NRC Resolution of Facility Comment

Facility Comment on Q57

Question 57

NSA Position Control Group On / Backup Heaters in Auto

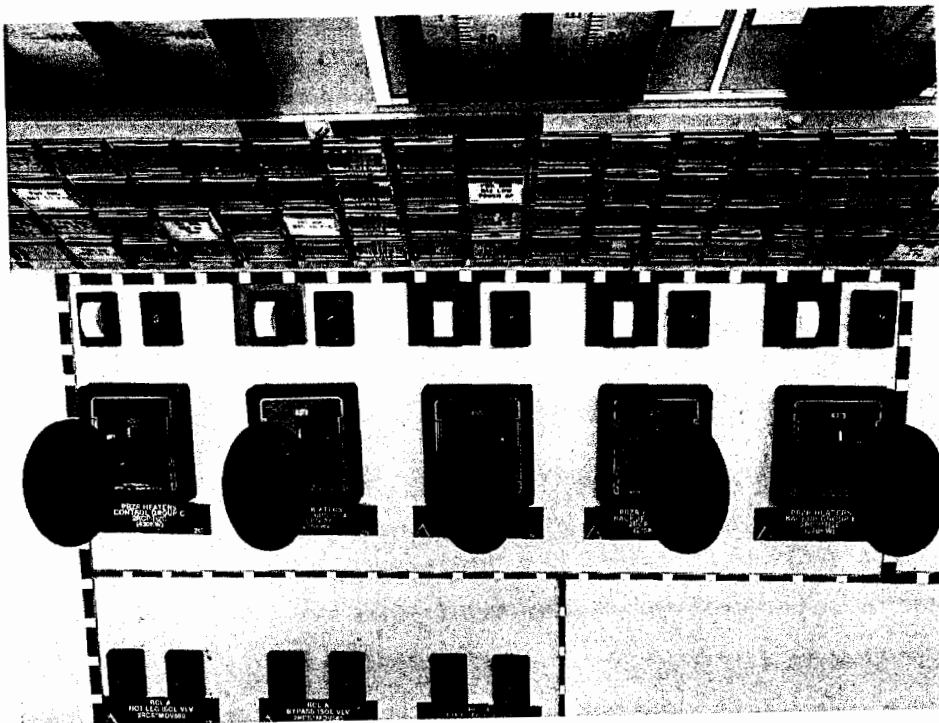
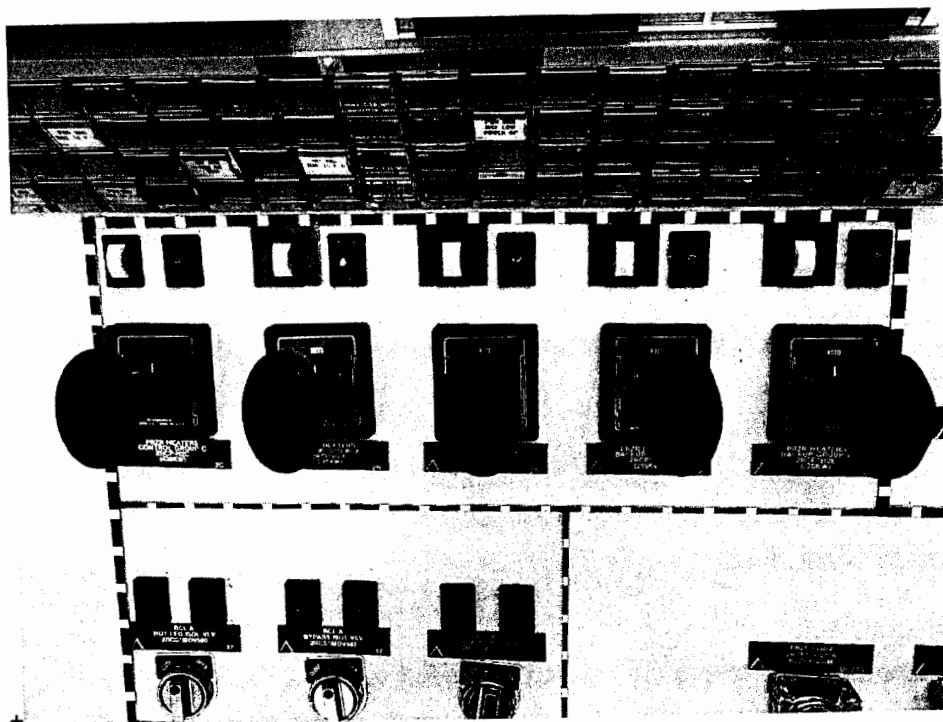
The question asks the applicant to determine the status of pressurizer heaters based on plant conditions. The terminology used in the distractors is "ON" and "OFF"; this is unclear because "ON" and "OFF" are control switch positions, whether or not heaters are "ENERGIZED" or "DEENERGIZED" depends both on switch position and, for proportional heaters, on whether or not the master pressure controller is providing a demand. Accordingly, two correct answers 'B' and 'C' should be accepted.

The normal switch position of the Proportional heaters is After-ON (see attached 2OM-6.3.C “Power Supply and Control Switch List”). In this condition, the benchboard red light is illuminated (see attached image).

The Proportional heaters are referred to in plant procedures as "ON" when the control switch is in the After-ON position (see attached 2OM-6.1.D). They will be energized or deenergized based on the output of 2RCS-PK444.

Given the plant conditions in the stem of the question (specifically the 8% PRZR level surge), the Proportional heaters would remain ON and deenergized (benchboard red light illuminated but no output based on the 42% output of 2RCS-PK444) AND the Backup heaters would be ON and energized (benchboard red lights illuminated due to the 8% PRZR level surge). See attached images reflecting NSA and conditions after the 8% PRZR level surge.

Facility comment accepted, two correct answers accepted. Five applicants missed the question. The examiner reviewed documentation provided by the facility, exam bank questions for this system, and the system lesson plan. All use the "energized" or "deenergized" terminology to describe whether or not the heaters are powered, and "ON" or "OFF" for breaker position.

NSA Position Control Group On / Backup Heaters in Auto

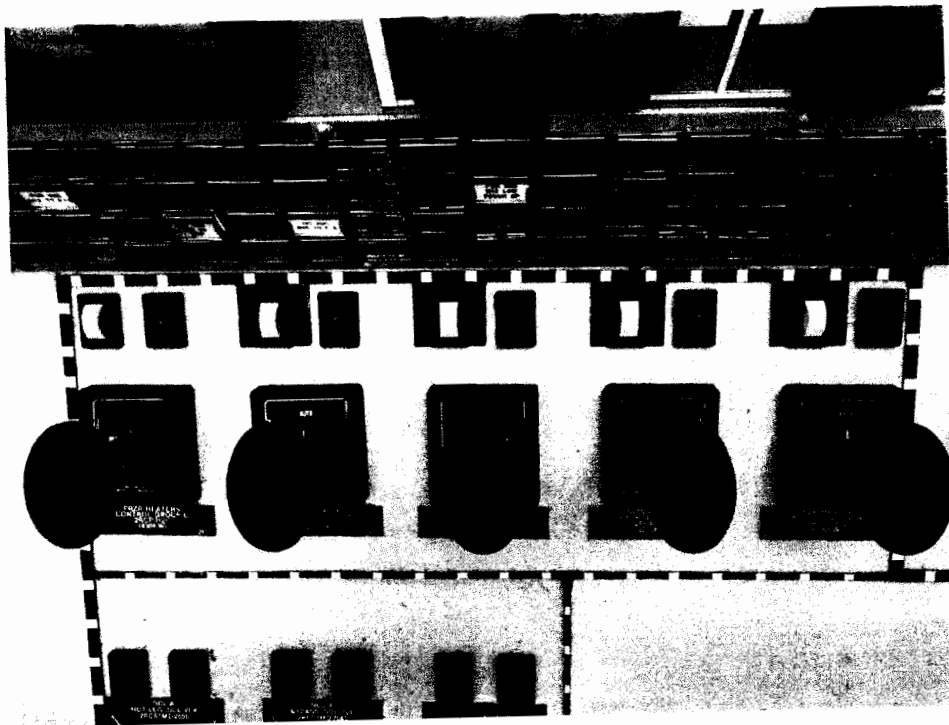
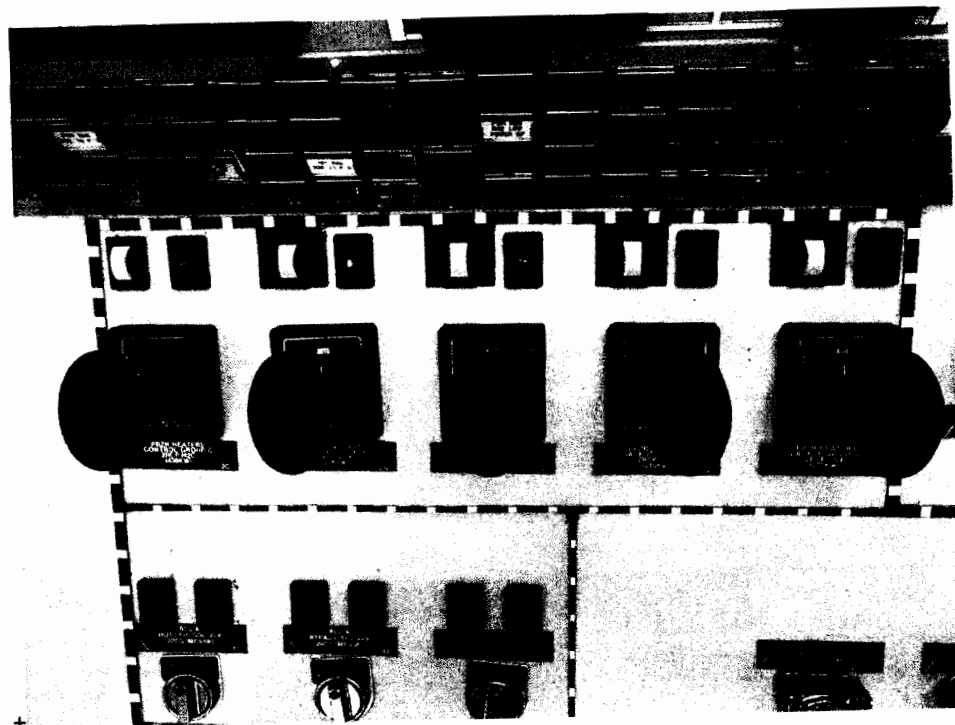
The normal switch position of the Proportional heaters is After-ON (see attached 2OM-6.3.C “Power Supply and Control Switch List”). In this condition, the benchboard red light is illuminated (see attached image).

The Proportional heaters are referred to in plant procedures as "ON" when the control switch is in the After-ON position (see attached 2OM-6.1.D). They will be energized or deenergized based on the output of 2RCS-PK444.

Given the plant conditions in the stem of the question (specifically the 8% PRZR level surge), the Proportional heaters would remain ON and deenergized (benchboard red light illuminated but no output based on the 42% output of 2RCS-PK444) AND the Backup heaters would be ON and energized (benchboard red lights illuminated due to the 8% PRZR level surge). See attached images reflecting NSA and conditions after the 8% PRZR level surge.
